**Graymont Western U.S., Inc.**  
**Cricket Mountain Project, Utah**

**Notice of Intention to Revise Mining Operations**  
**Big Sage**

**Re:** Response to Review of Amended Notice of Intention to Commence Large Mining Operations, Graymont Western US, Inc. (Graymont), Big Sage, M/027/006, Task ID# 1826, Millard County, Utah.

**Figure 7. Conceptual Stormwater Management Map**

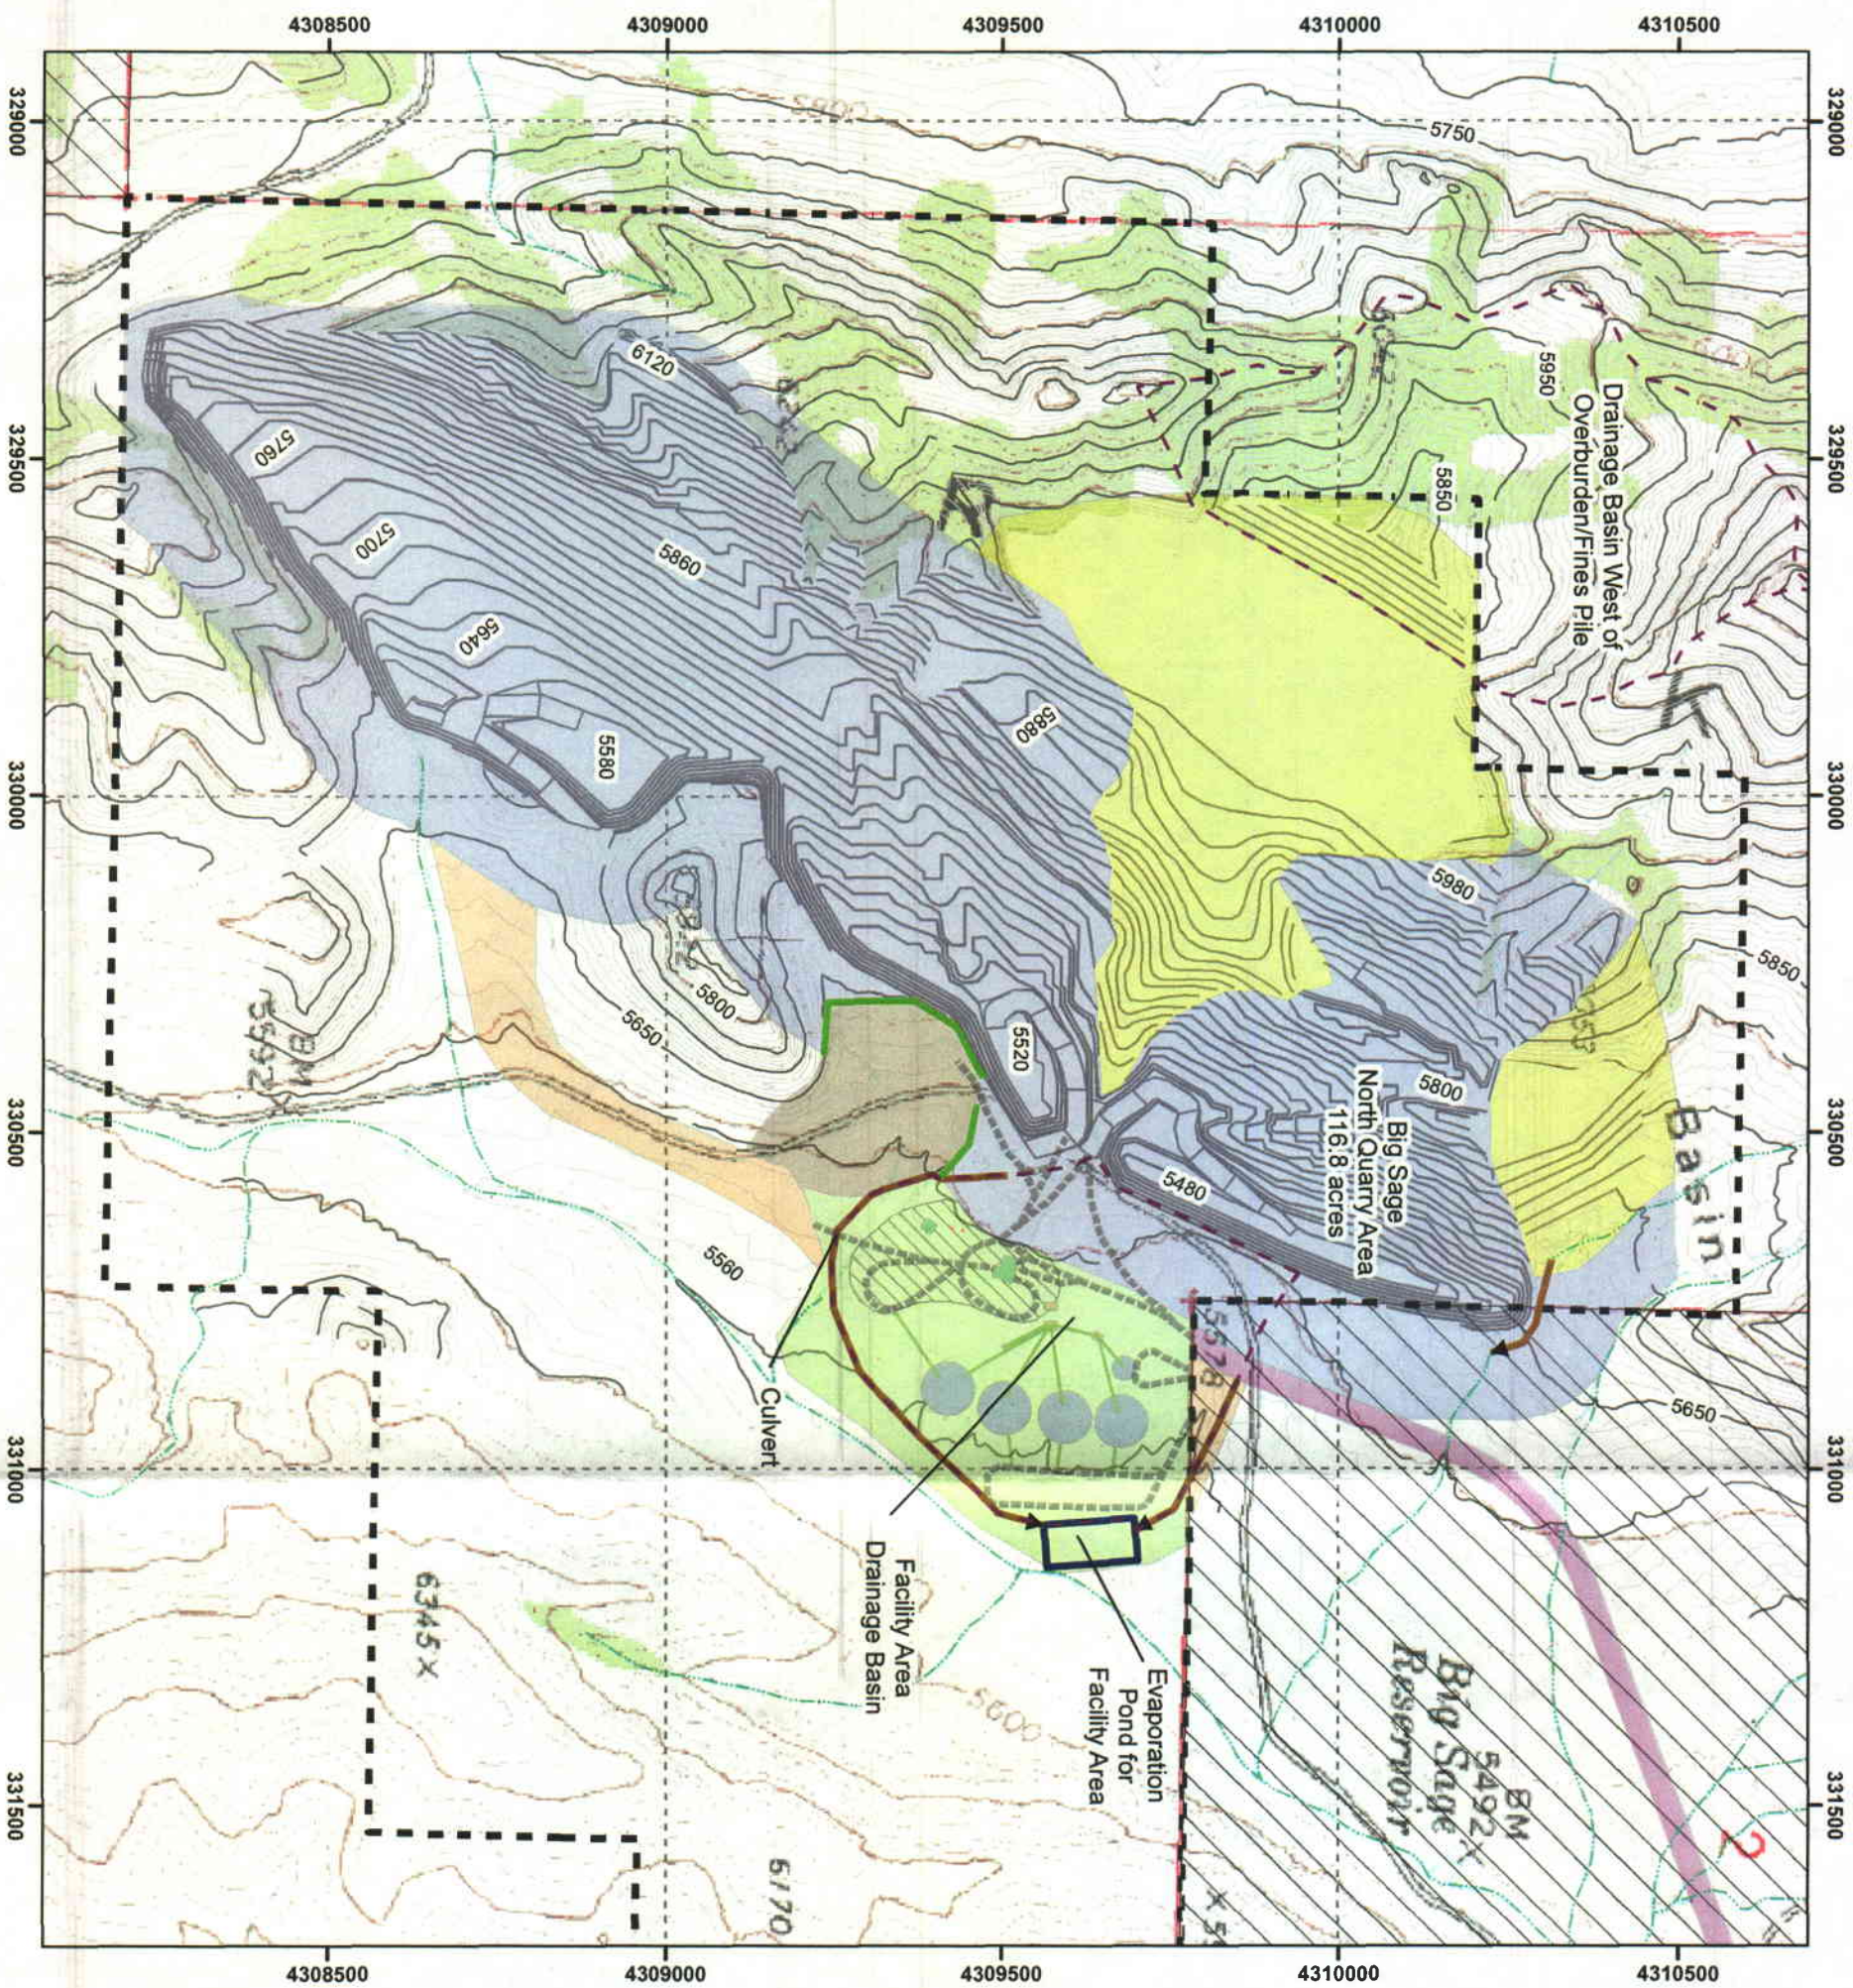
**The watershed map, Figure 7, is of too large a scale to show watershed boundaries. In order that the Division accept this plan it is required that the boundaries of the contributing watersheds be shown and the resulting drainage and impacts be clearly shown. Figure 7 fails to clearly show all these boundaries as the figures does not show a large enough area or provide all the drainage boundaries and contributing watershed areas. Diversion ditches, berms, swales, and ponds are identified without any engineering detail in the plan. Please provide this detail. (TM)**

**According to Figure 7, several ephemeral streams will be impacted by mining operations. The plan states, “no impacts to surface water resources are projected”,**

As per the May 6, 2008 meeting, the text has been modified to state, "No impacts to surface water resources are projected beyond what is shown on Figure 7".

**Figure 9. Conceptual Reclamation Map**

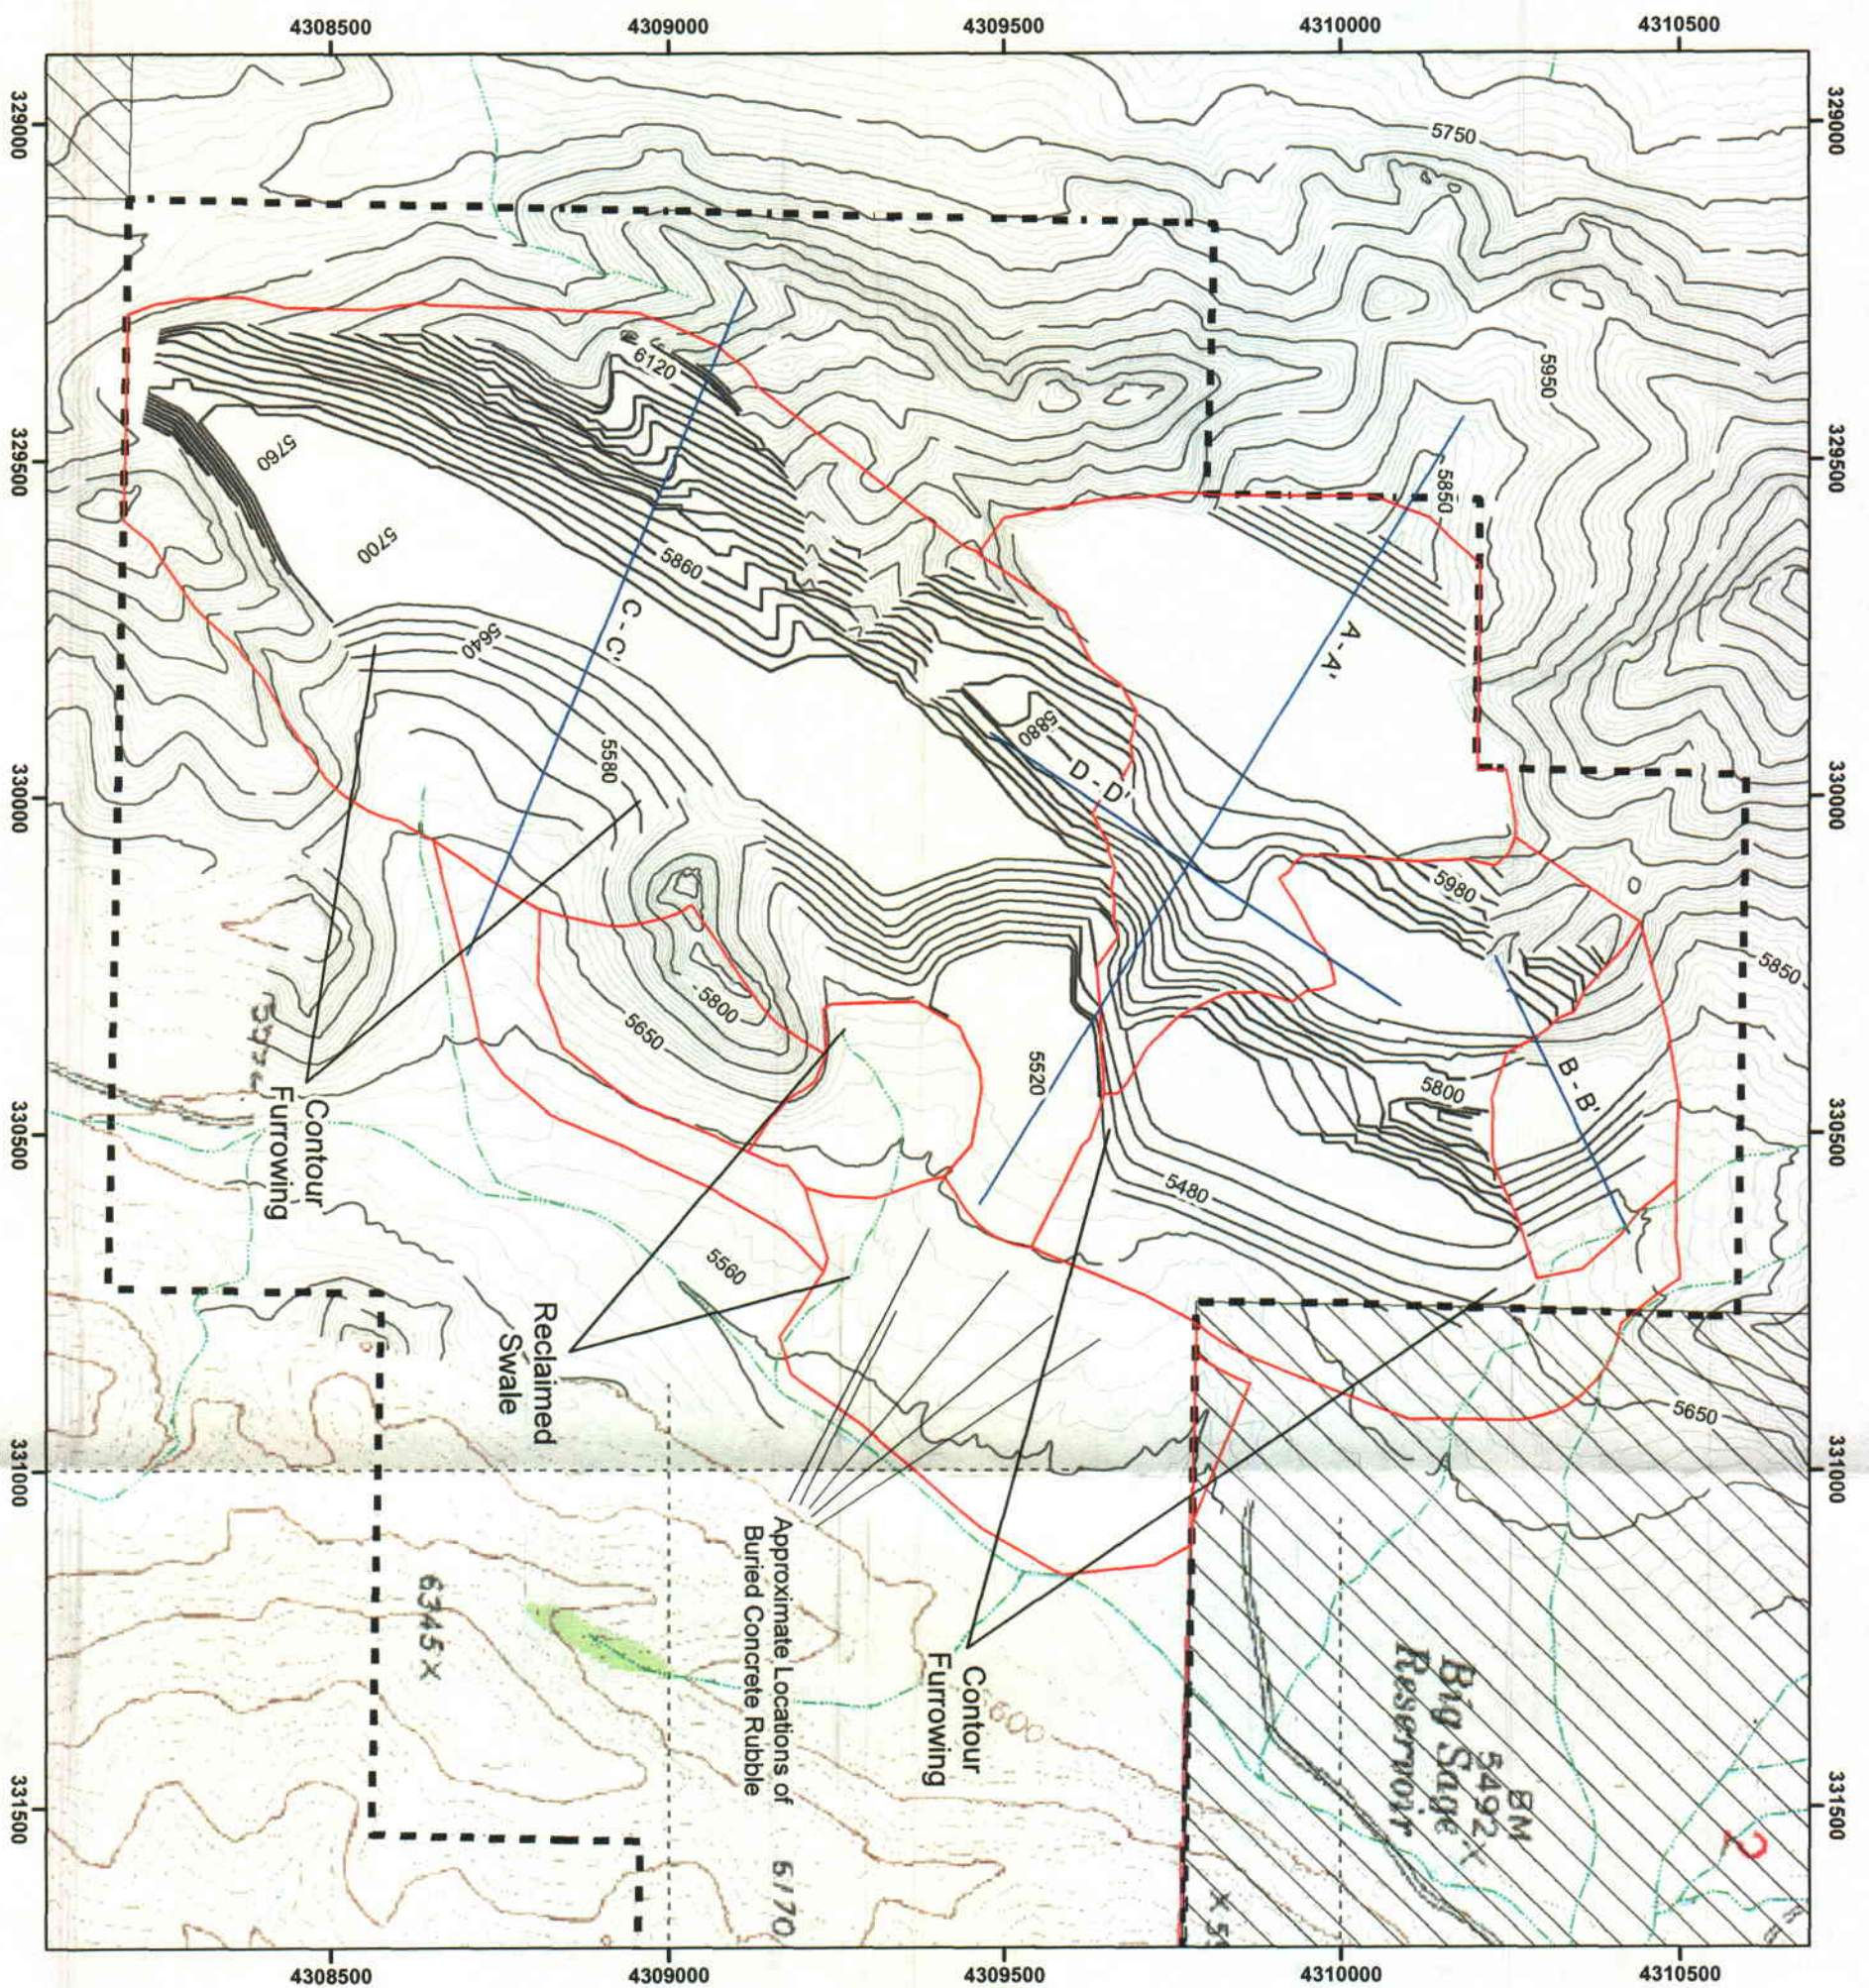
Figure 9 shows some areas where no revegetation will be done, and Section 4.6.3 says slopes of the overburden/fines piles that are recontoured to an angle safe for equipment will be covered with a layer of soil and seeded. This appears to be a variance, and the plan needs to include either a variance request with adequate justification or it needs to show why this is not a variance. If the overall site, including these unvegetated areas, will have 70 percent of the pre-mining vegetative cover, then no variance is needed. If a variance is requested, it will need to show the variance requested and the area that would be affected, justification for the variance, and alternate methods or measures to be utilized. (PBB)

Figure 9 has been revised to show projected contour furrowing locations.

Figure 9 has been revised to show the reclaimed swale location.

Assuming sufficient soil is available, the overall site will be revegetated to 70 percent of existing vegetative cover. Figure 9 has been updated to indicate this.
